Project	IEEE 802.16 Broadband Wireless Access Working Group < http://ieee802.org/16 >	
Title	The Passive Multi-hop Relaying HARQ Mechanism	
Date Submitted	2007-04-29	
Source(s)	Wei Ni, Kaibin Zhang, Gang Shen, Shan Jin Alcatel-Lucent, Research & Innovation No. 388, Ningqiao Rd., Pudong Jinqiao, Shanghai, P. R. C	Voice: 86-21-50554550 Fax: 86-21-50554554 mailto: wei.a.ni@alcatel-sbell.com.cn
	Fang Liu, Lan Chen, Xiaoming She, Daqing Gu DoCoMo Beijing Lab 7/F, Raycom Infotech Pack Tower A No.2 Kexueyuan South Rd., Haidian District, Beijing, China	Voice: +86-10-82861501 ex.331 Fax: +86-10-82861506 mailto: {liu, gu }@docomolabs-beijing.com.cn
	Fujio Watanabe DoCoMo USA Labs 3240 Hillview Avenue, Palo Alto, CA	Voice: 650-496-4726 mail to: watanabe@docomolabs-usa.com
	Rakesh Taori, Mi-Sun Do Samsung Advanced Institute of Technology	Voice: +82-31-280-9635 mailto: rakesh.taori@samsung.com
	Youngbin Chang, Samsung Electronics 416, Maetan-3dong, Youngtong-gu, Suwon- si, Gyeonggi-do, Korea	Voice: +82-31-270-5519 mailto: yb.chang@samsung.com

IEEE C802.16j-07/252r2

The Passive Multi-hop Relaying HARQ Mechanism

Figure 130jc (a): The passive MR HARQ mechanism for the uplink HARQ bursts

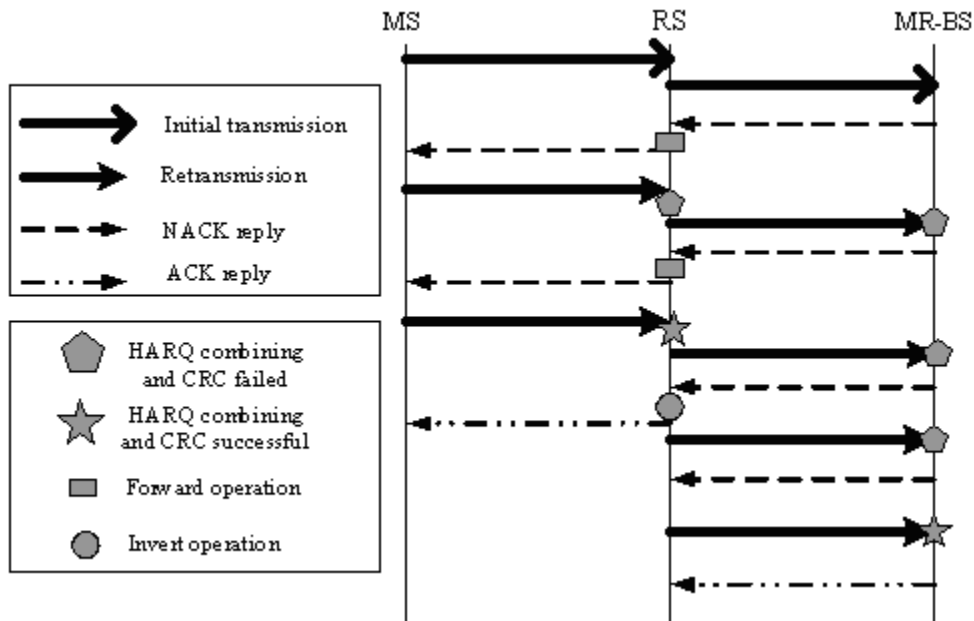
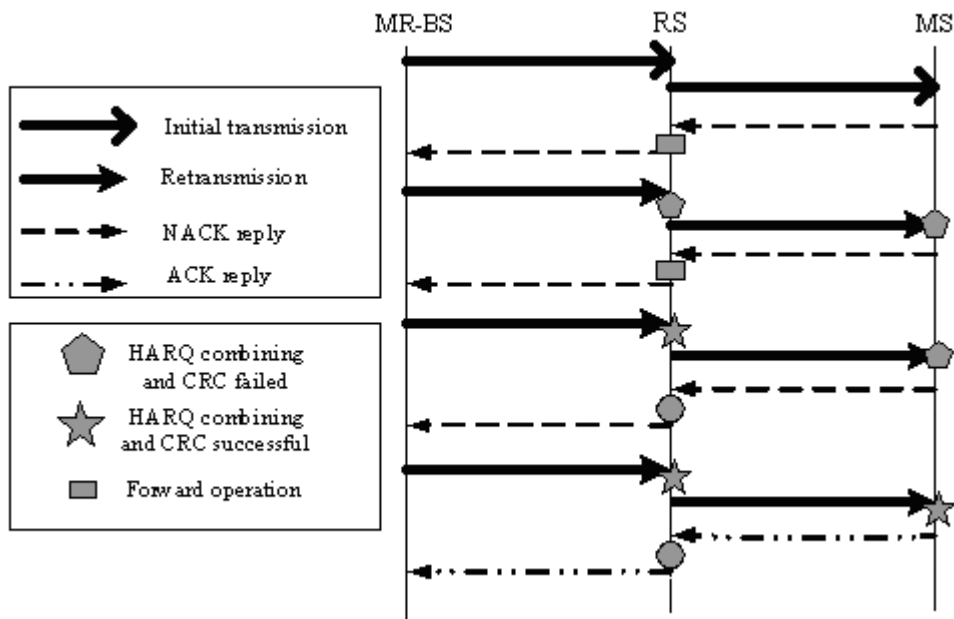
[Insert new sub-clause 6.3.17.4.2 and add figures]

The principle and process of the passive MR HARQ is illustrated in Figure 130jc.

In both uplink and downlink, the source transmits its packets to the RS. The RS forwards the packet to the destination. ACK is sent back to the source via hops from the destination after a fixed delay defined by HARQ_ACK_Delay for UL or DL burst which is specified in DCD message, if the received packet succeeds in the CRC verification. Otherwise, NACK signal is transmitted. The intermediate RSs simply forward the

Only when a NACK is received for the previous HARQ attempt or an ACK is not received properly, a retransmission is conducted by the source. The intermediate RS performs CRC verification and may perform HARQ combining. If an RS performs HARQ combining and the corresponding combined HARQ burst passes the CRC verification, the RS sends an ACK signal to the source and the RS may play the role of the source in the following HARQ retransmission. If the CRC verification fails, the RS may forward the erroneous burst to the next hop. When forwarding an erroneous HARQ burst, regardless of the MCS level used for forwarding, the RS shall indicate to the next hop station that the HARQ burst is in error.
